ADDENDUM #1:

RECORD DRAWING

CITY OF WICHITA
BR. NO. 54-87-19.05 (489) W.B. STA. 15+612.397
BR. NO. 54-87-19.06 (491) E.B. STA. 15+612.397

CIRCULAR WALL DETAILS

ELEVATION

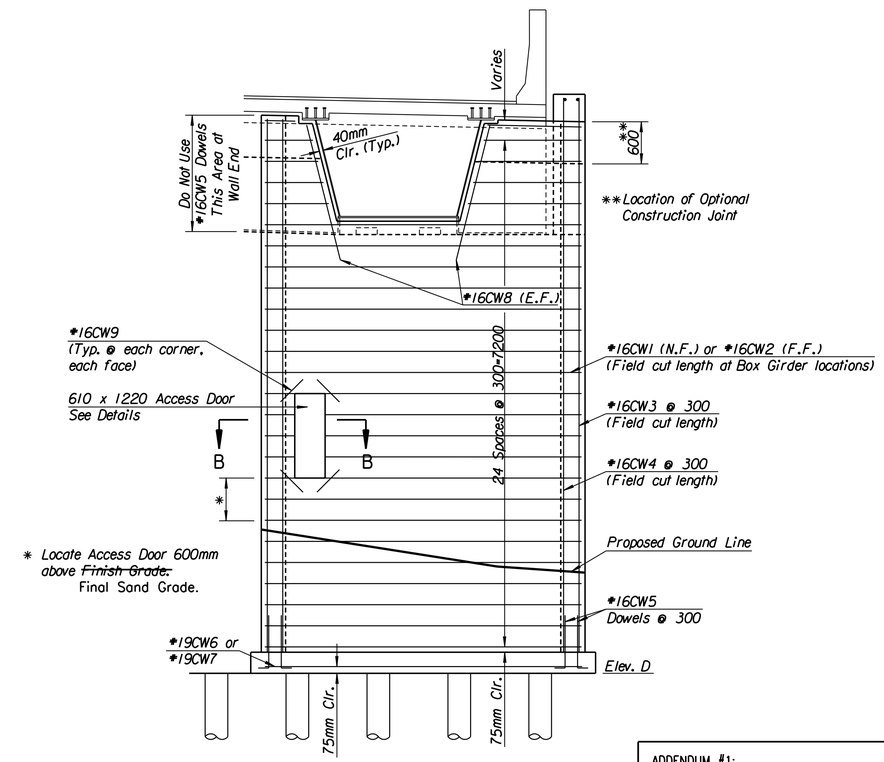
Note:
Bridge Contractor field fitted and attached an angled, galvanized metal strip to cover exposed opening at top of semi-circular room to restrict excessive moisture gaining access to room. Metal strip was attached with screws and sealing compound in a manner that allowed some flexibility of metal strip during bridge structure movement. One (1) metal strip attached per semi-circular room location [four (4) total]. See Field Order 6-14-04.

ACCESS DOOR

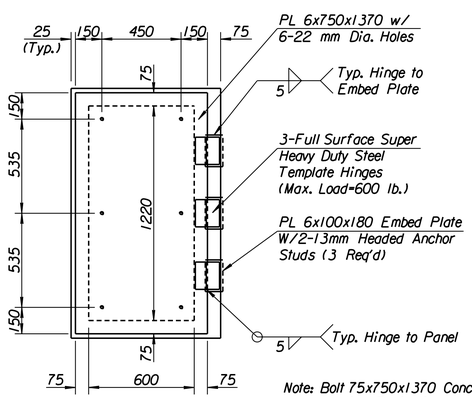
Sheet 449 and Sheet 579 Add the following notes:

1. The exterior exposed face of the circular walls including the access door shall be a smooth textured surface and stained with the "Surface Coating Finish" in accordance with the specifications. Circular walls shall be measured and paid for at the unit prices bid for "Concrete (Grade 30)(AE) and Reinforcing Steel (Gr. 420). Quantities are included in the Substructure Quantities.

~~Access Door at Circular Wall locations is subsidiary to bid item Reinforced Concrete Circular Walls.~~ Quantities for Circular Walls are listed in the Substructure Quantities on the General Notes sheets. No deductions in Concrete and Reinforcing were made for Access Door openings.
